**LAKE MANITOBA AND LAKE ST. MARTIN OUTLET CHANNELS PROJECT
SUPPLEMENTAL SUBMISSION**

**MTI's response to IAAC's Attachment 1: Outstanding Information in
Response to Information Request Round 1 (Amended)
(dated June 6, 2022 and amended June 22, 2022)**

Attachment 1: Outstanding Information in Response to Information Request Round 1 (Amended)

Lake St. Martin: Pre-Project 2011 Flood Peak

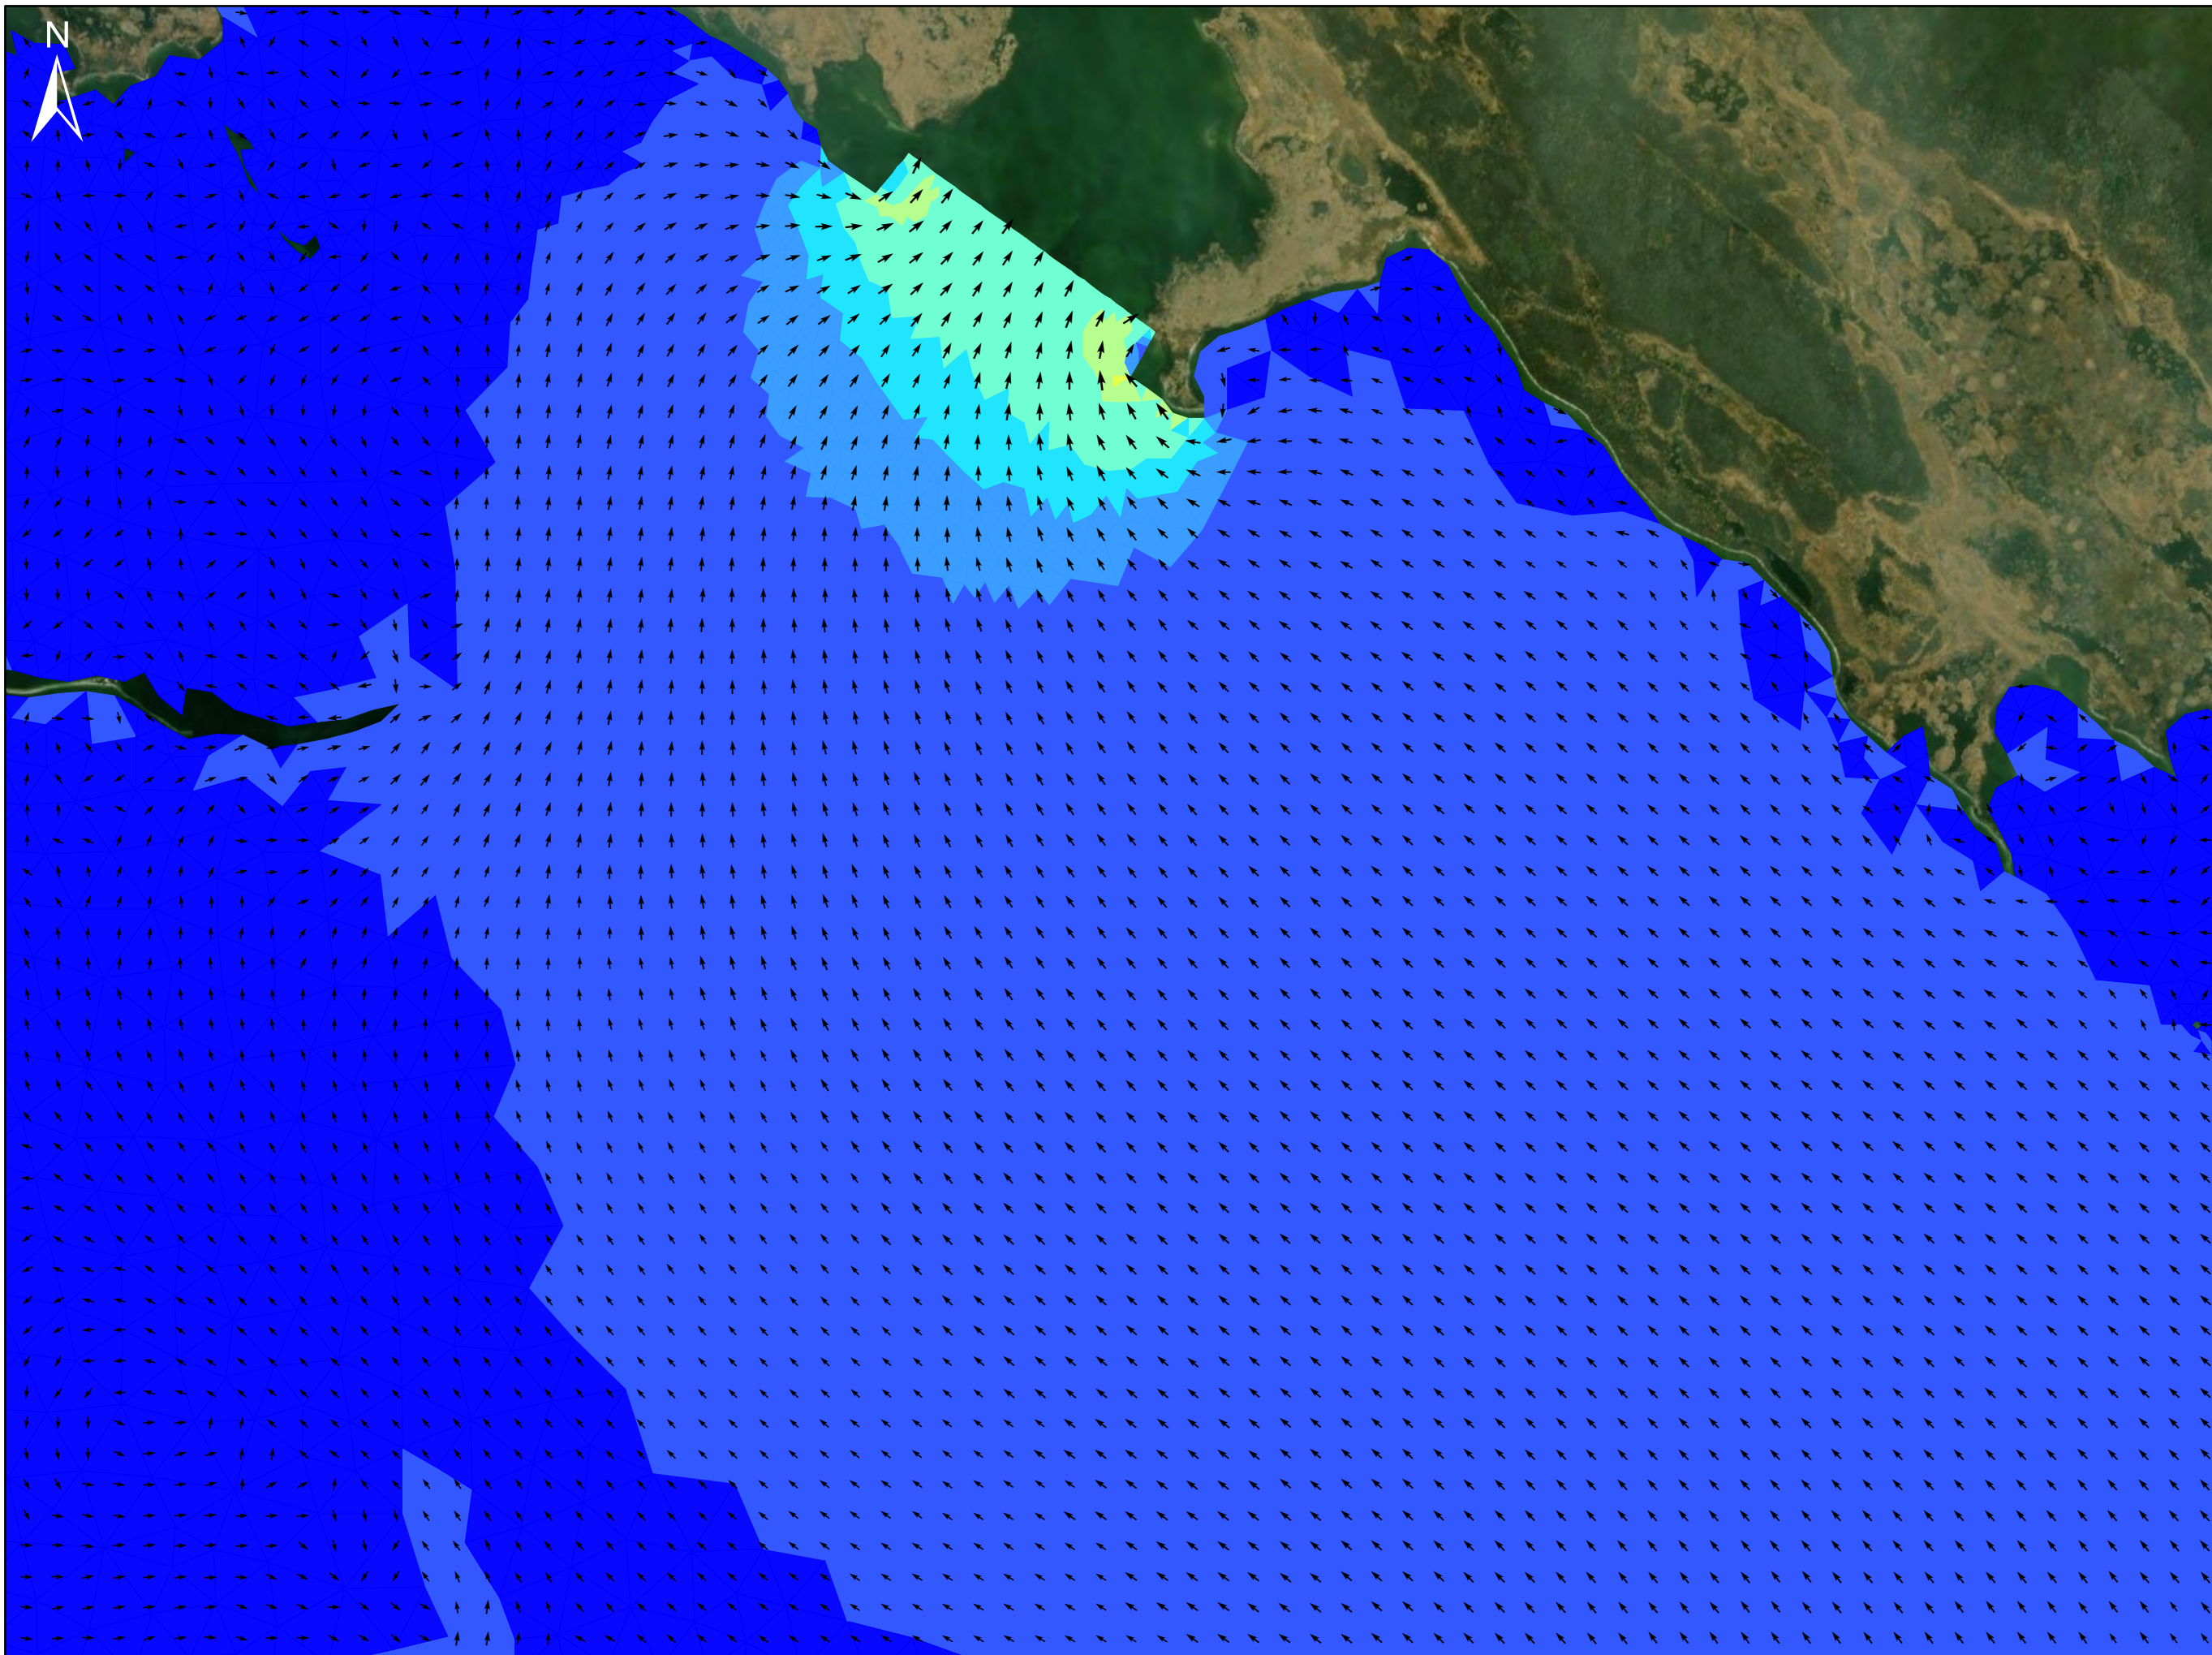
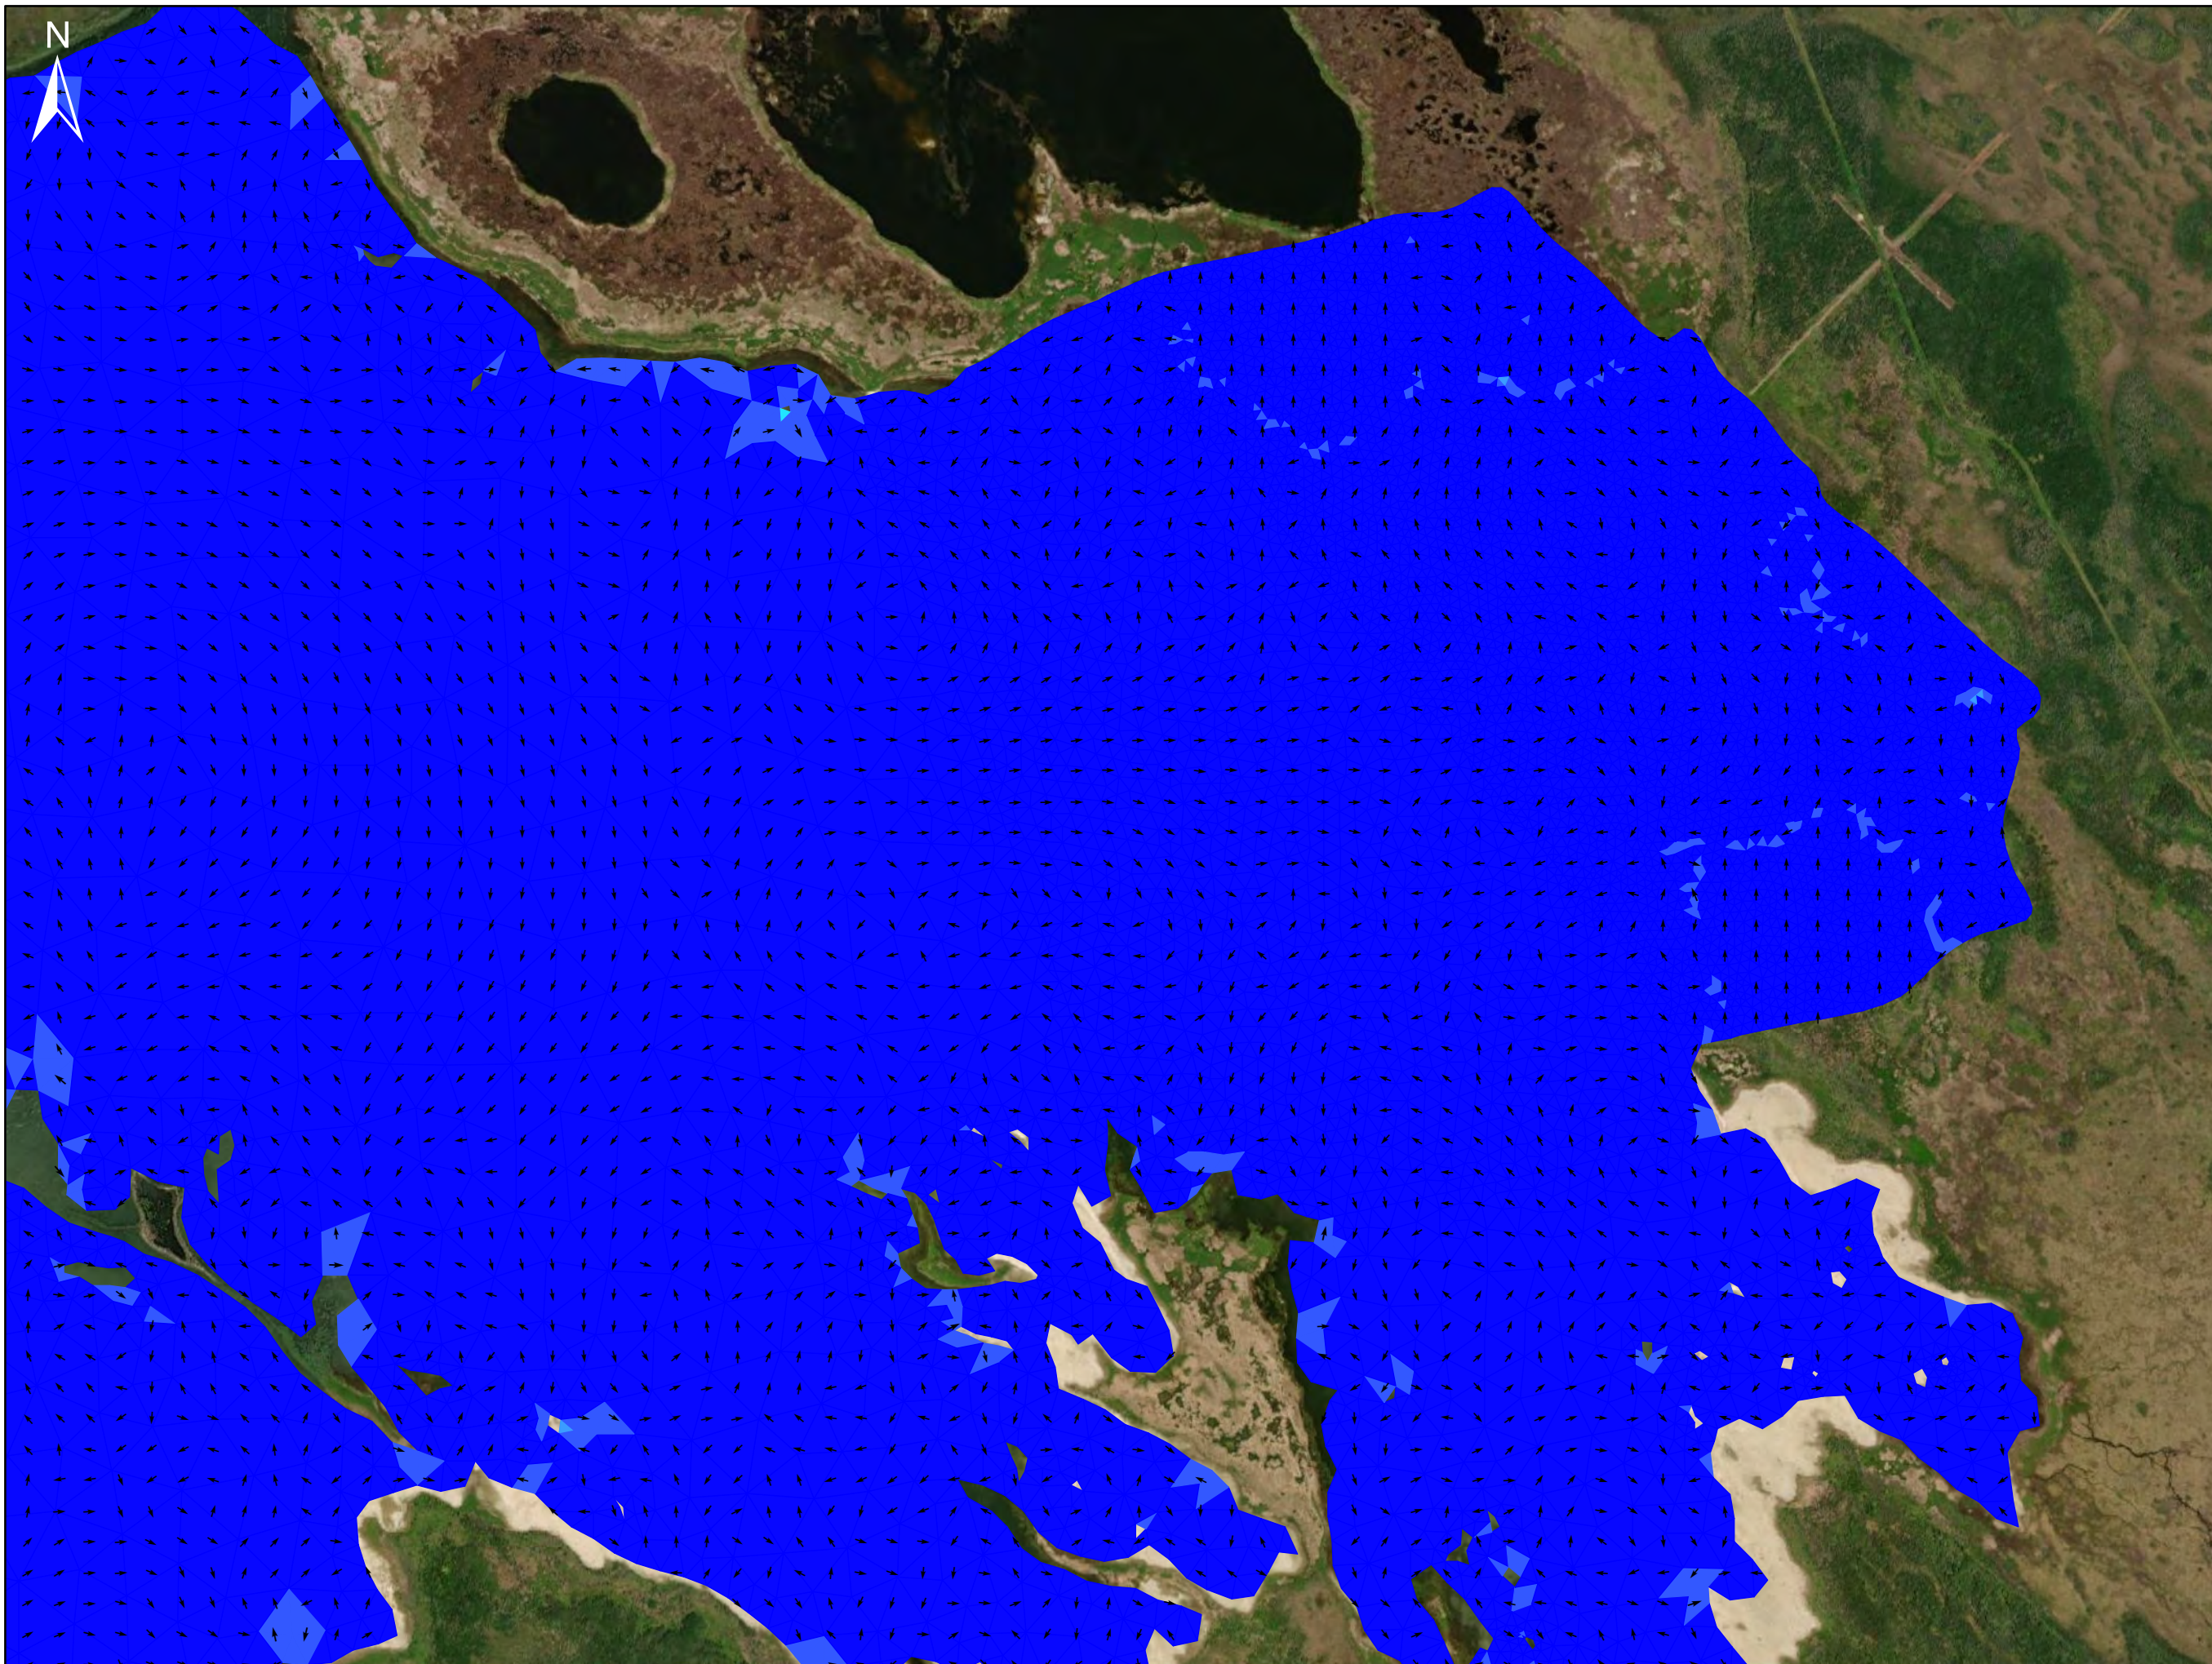
| # | Item | Comment | Request | Response (revisions shown in red) |
|----|---|--|---|---|
| 20 | IAAC-84: Missing Information | Appendix IAAC-84A appears to be missing. | Provide the missing information. | Appendix 84A: Velocity contour maps for Lake St. Martin illustrating passage of the 2011 peak flows for the pre- and post-Project environment are included in Appendix IAAC-84A This information is included; see the Appendix 84A velocity figures |
